BRANSON WEST MUNICIPAL AIRPORT – EMERSON FIELD

ADDENDUM NO. 1

Project No. AIR 206-099A-1

**CONSTRUCT TAXILANE, FOUR-UNIT T-HANGAR AND TWO BOX
HANGARS**

PROJECT NO. AIR 206-099A-1
CONSTRUCT TAXILANE, HANGARS
PROPOSED TYPICAL SECTIONS

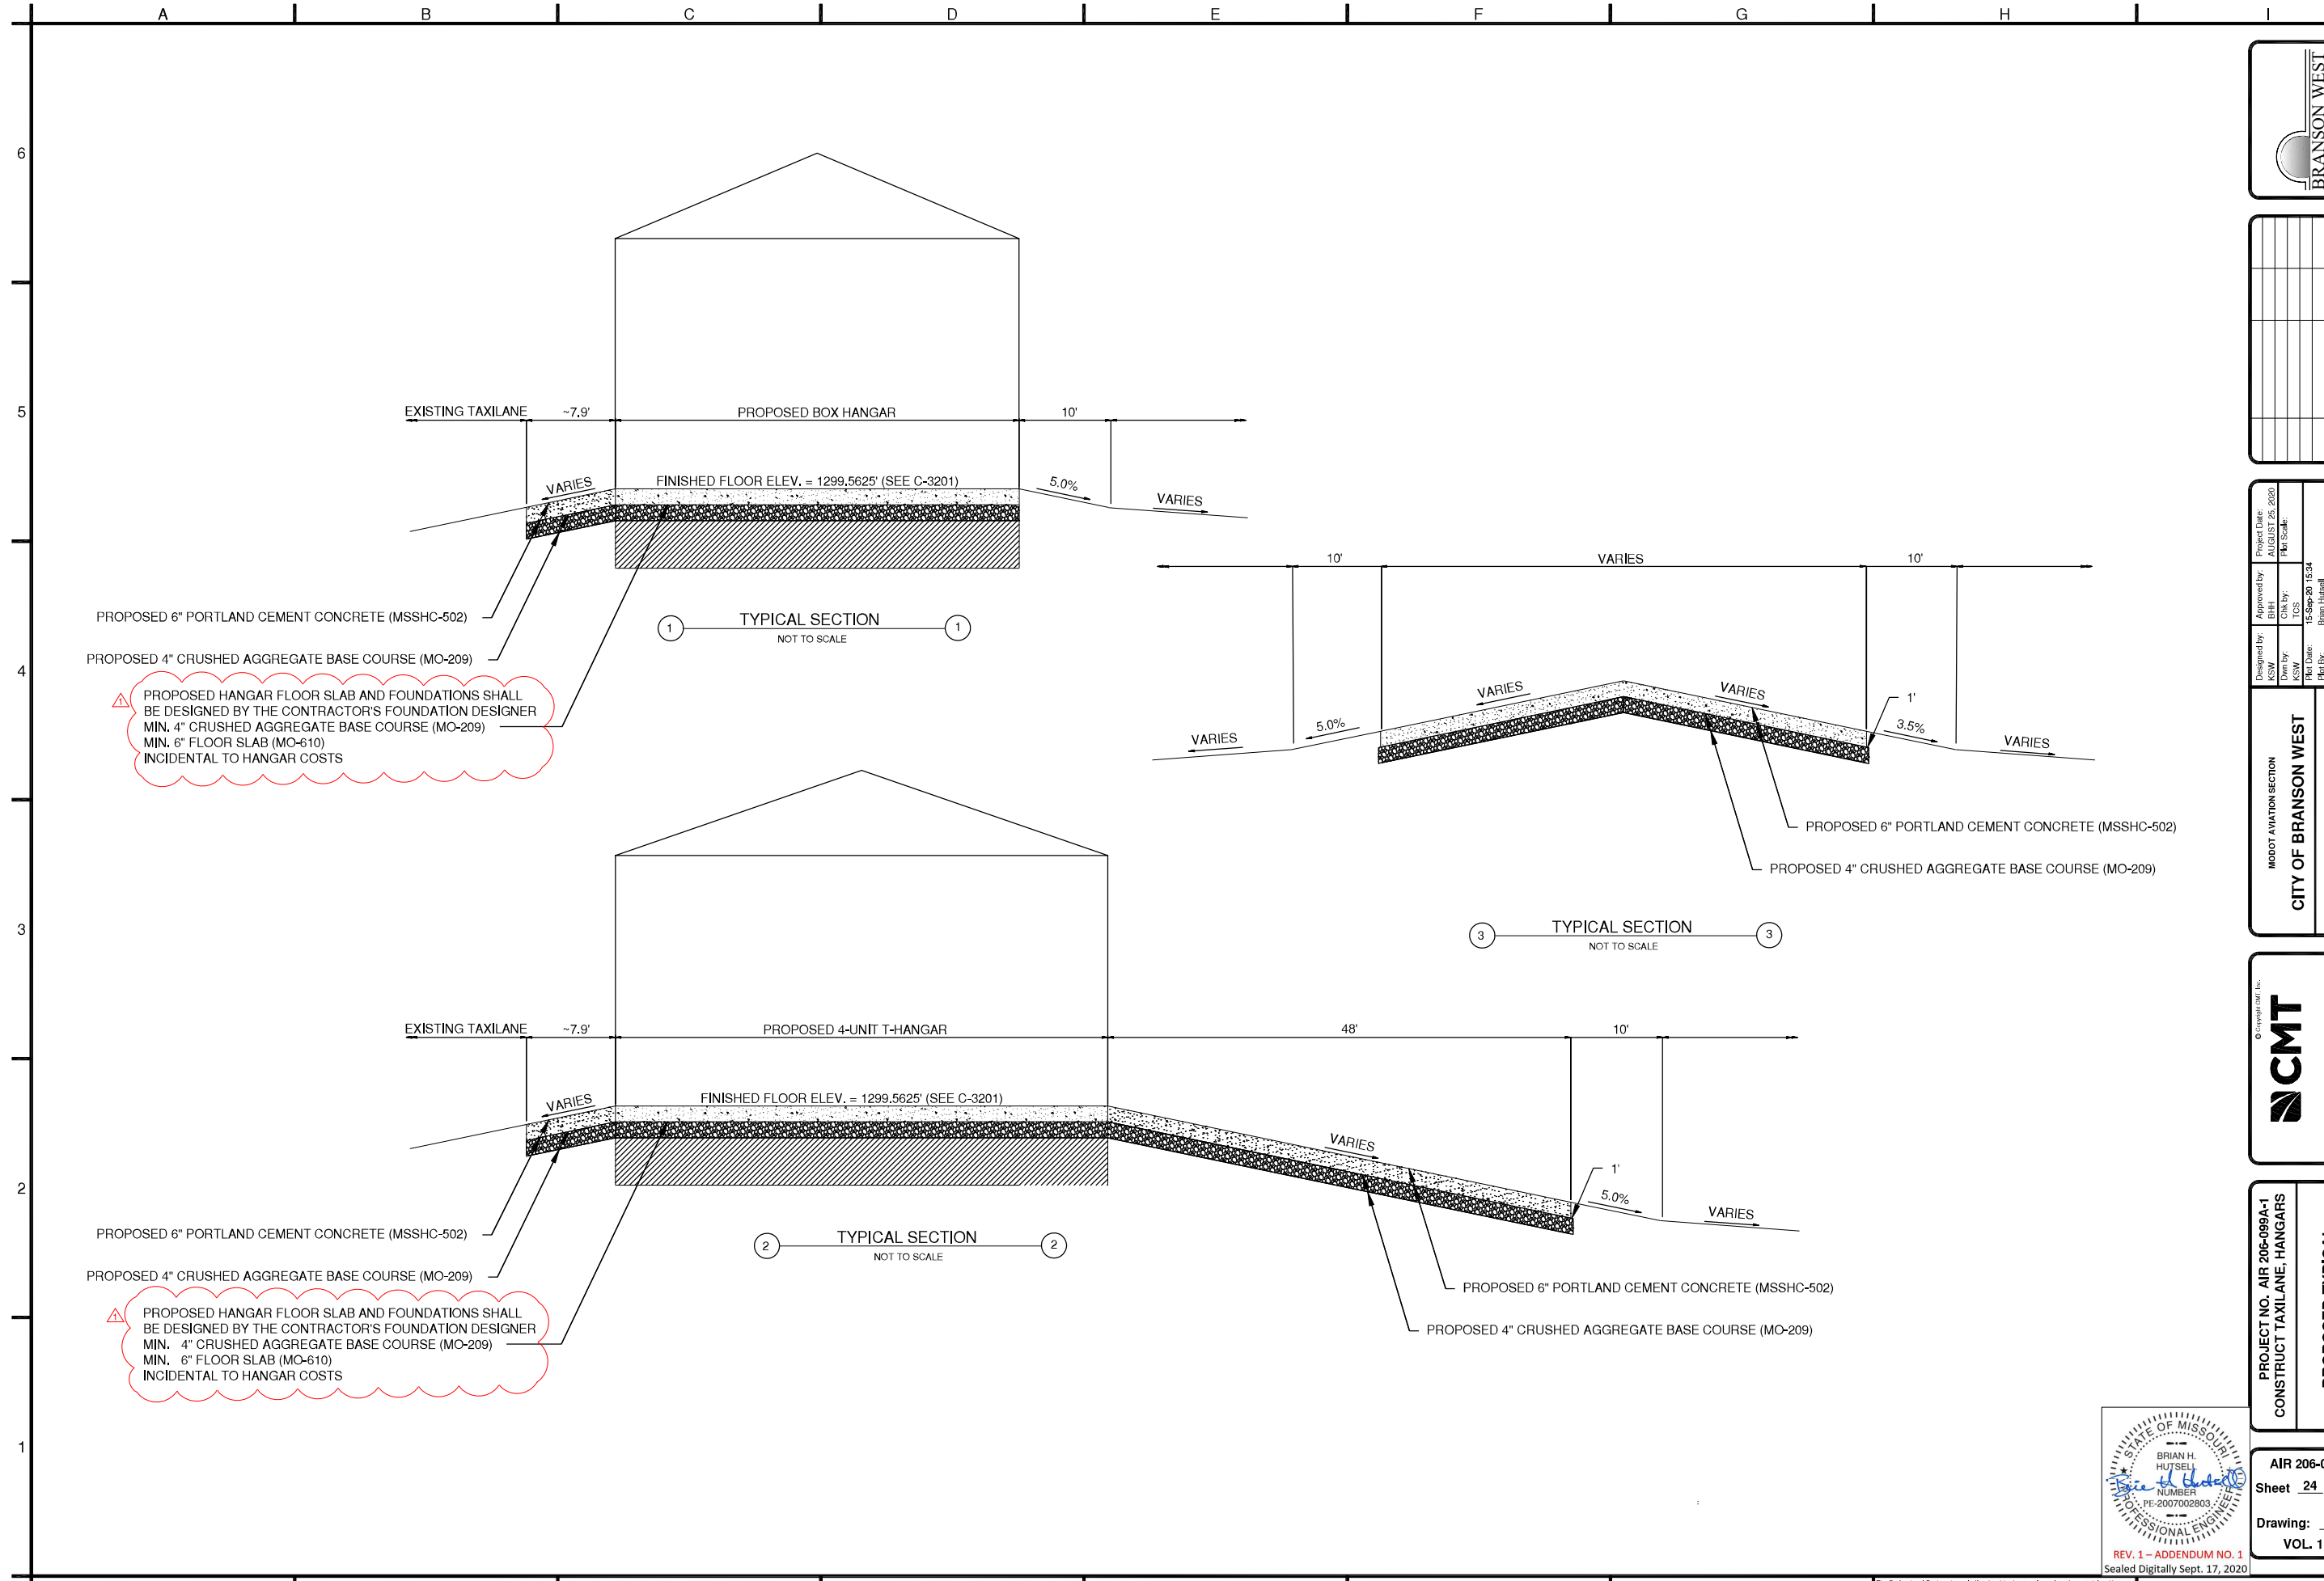
CLARIFICATION: This sheet is clarifying the minimum hangar slab and aggregate base thickness, as well as the incidental nature of that work to the hangar pay items.

PROJECT NO. AIR 206-099A-1
CONSTRUCT TAXILANE, HANGARS
HANGAR FLOOR PLAN AND ELEVATIONS

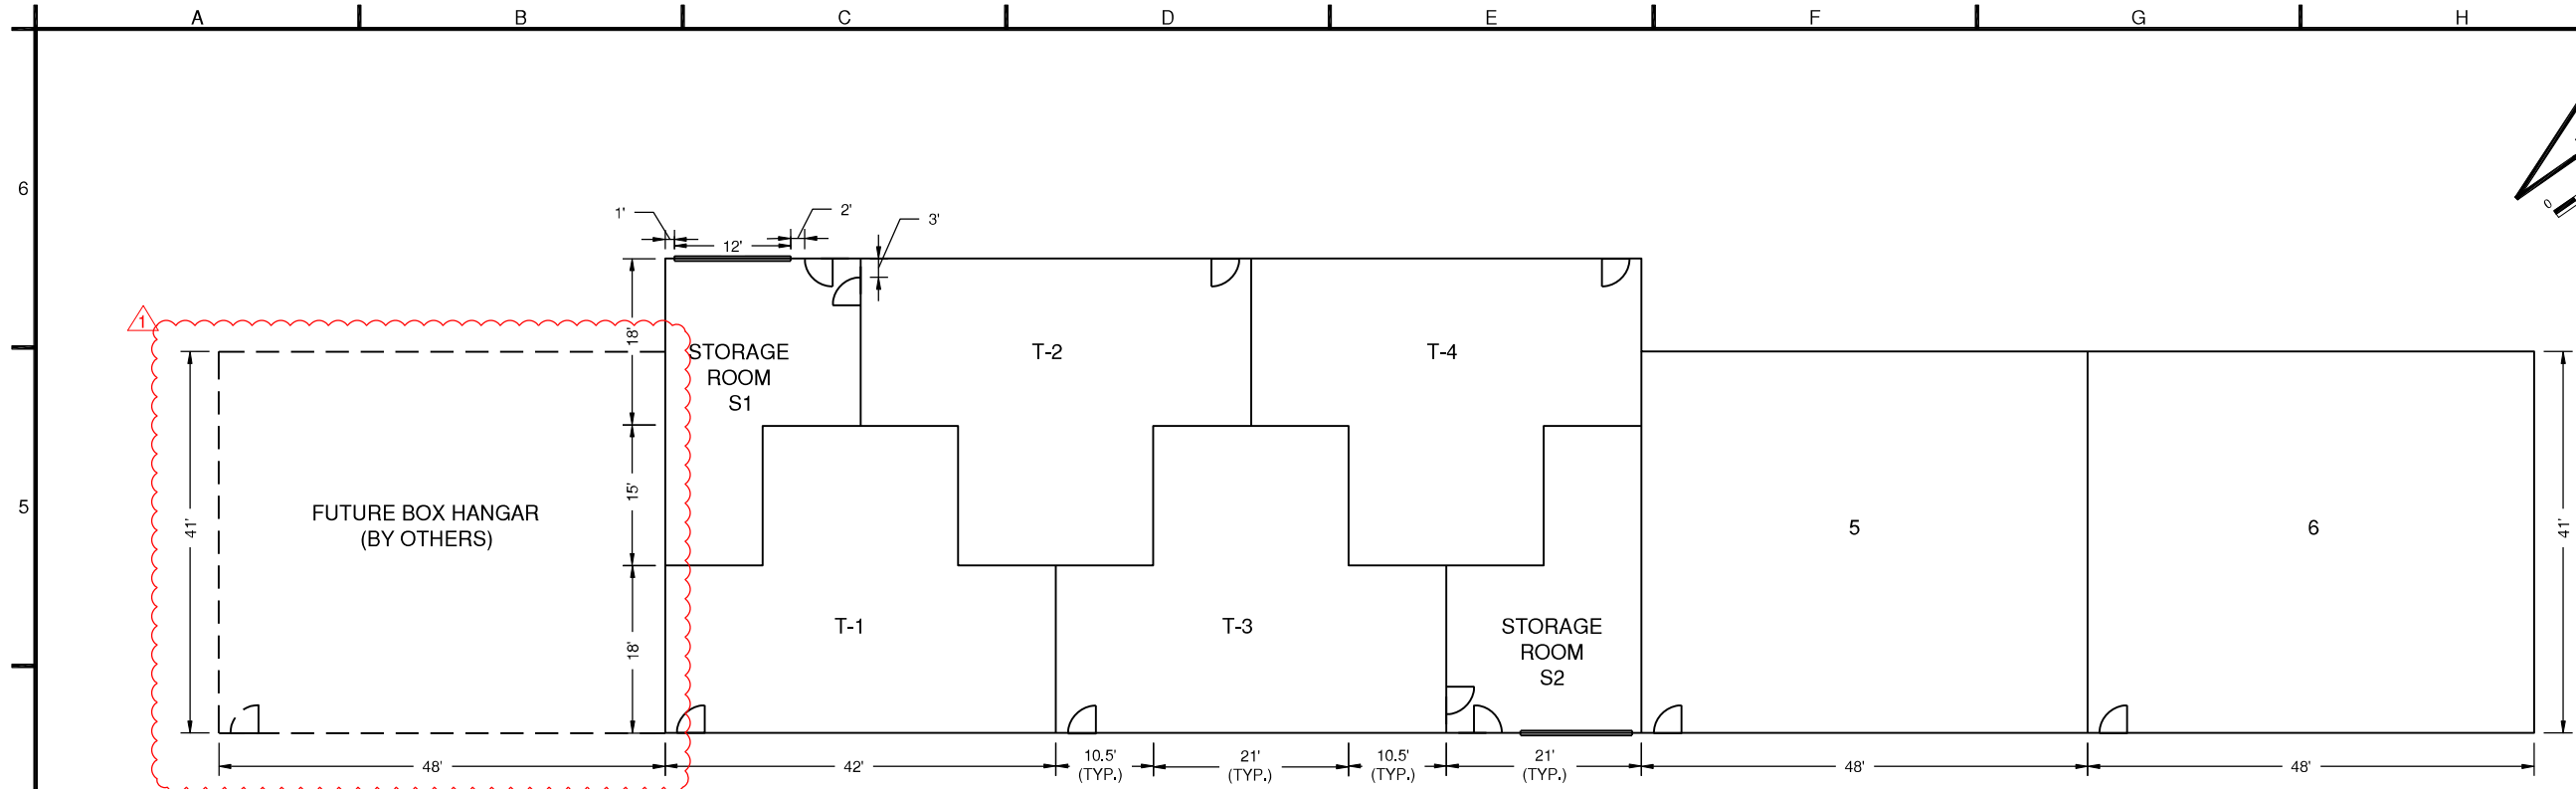
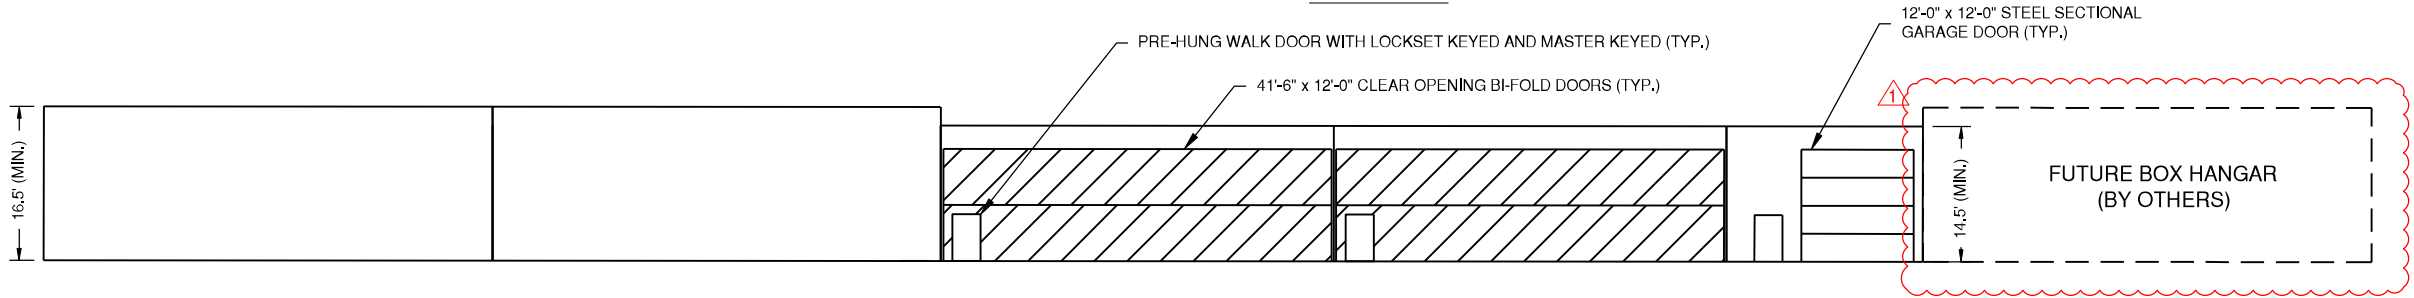
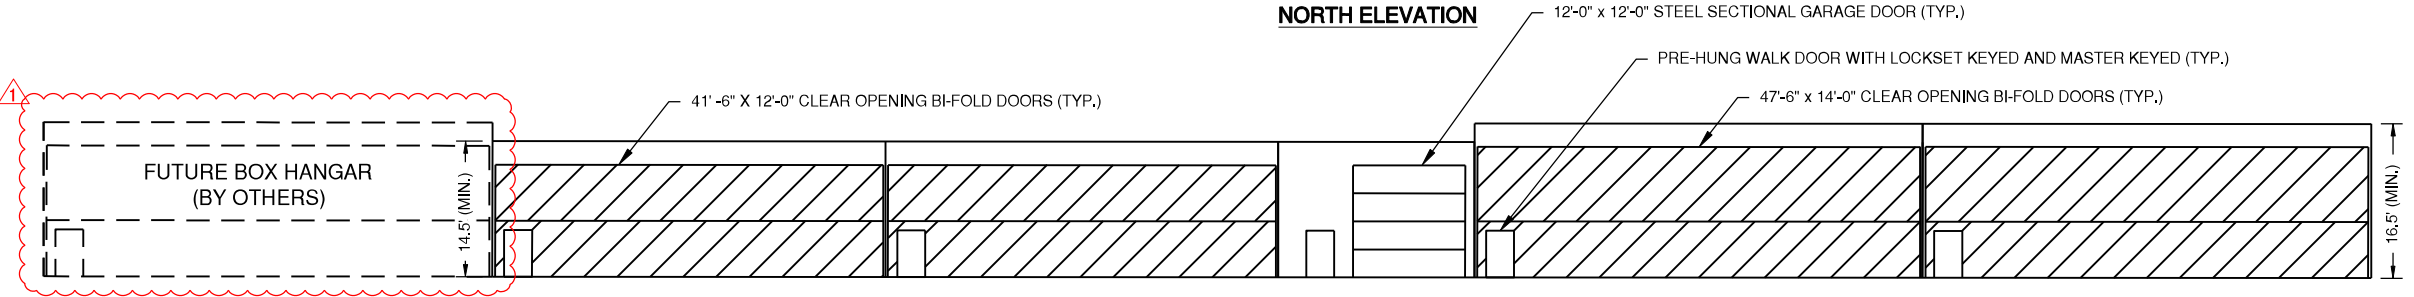
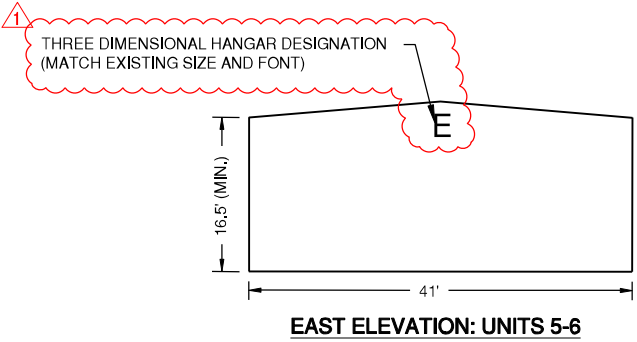
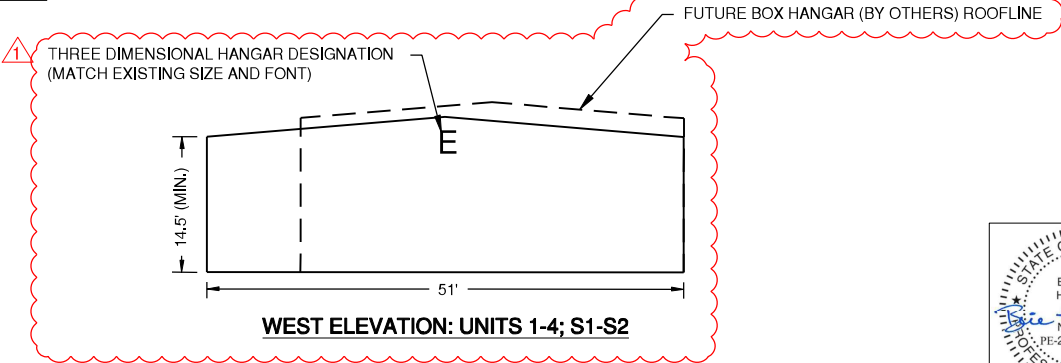
CLARIFICATION: This sheet now shows the future box hangar to be attached at the northwest end of the T-hangar buildings. Hangar complex signage is also shown.
